# APPEAL OF DENIAL OF DEVIATION REQUEST

## CHERRY SPRINGS RANCH

June 2021

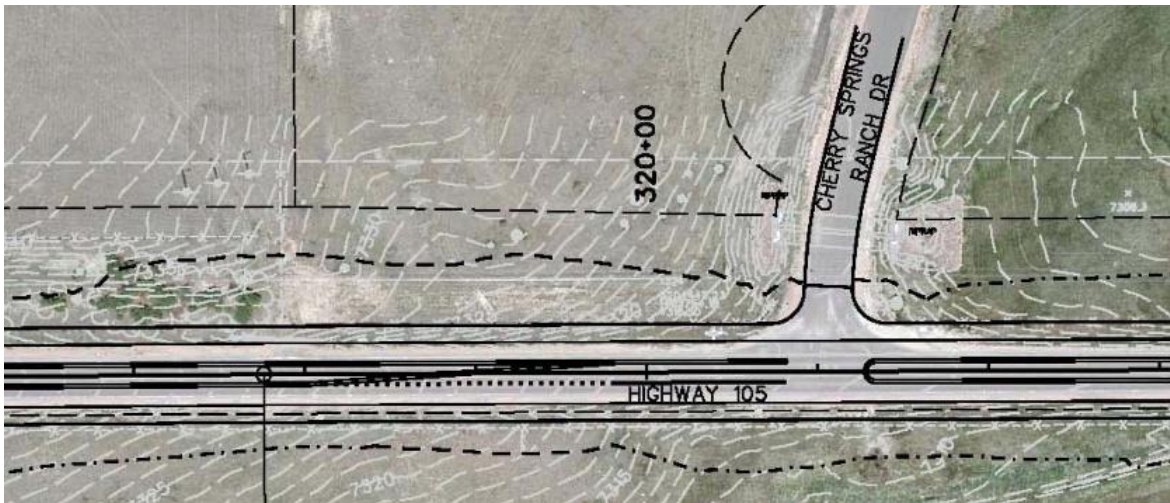
The closing of the intersection of Cherry Springs Ranch Drive (CSR) and 105 is conditioned with the construction of Appaloosa Drive into the site. The leaving of the CSR intersection would create two locations where the intersection spacing would not be in conformance with the criteria, creating a compromise in public safety. This road is anticipated to be a 4 lane principal arterial in which the proposed spacing would not be in the best interest of the safety of the function of 105.

The statement that there is no additional access is incorrect. CSR has access at Trumpeters court, as well, this intersection has no bearing on the creek crossing.

Due to the safety concerns, the CSR connection to 105 will need to be closed at the time Appaloosa Drive is extended into the site. Construction documents for the extension of Appaloosa should include the construction of the cul-de-sac and the closing of the connection.

The applicant is appealing the Deviation Request denial because public safety is best served by allowing the existing CSR Drive to remain open while allowing the proposed new access to CSR Filing 2 – the extension of Appaloosa Road. The proposal is for the CSR Drive/Highway 105 intersection to remain open as a full movement intersection until such time that Highway 105 is upgraded to the four-lane, Principal Arterial cross section per the roadway's MTCP classification. Once this occurs, the CSR Drive/Highway 105 intersection would likely be restricted to a right-in/right-out (or possibly a three-quarter movement intersection) with a future center median (part of the standard Principal Arterial cross section). The current roadway cross section/width is more like a Minor Arterial cross section. Quarter-mile intersection spacing is standard on Minor Arterials.
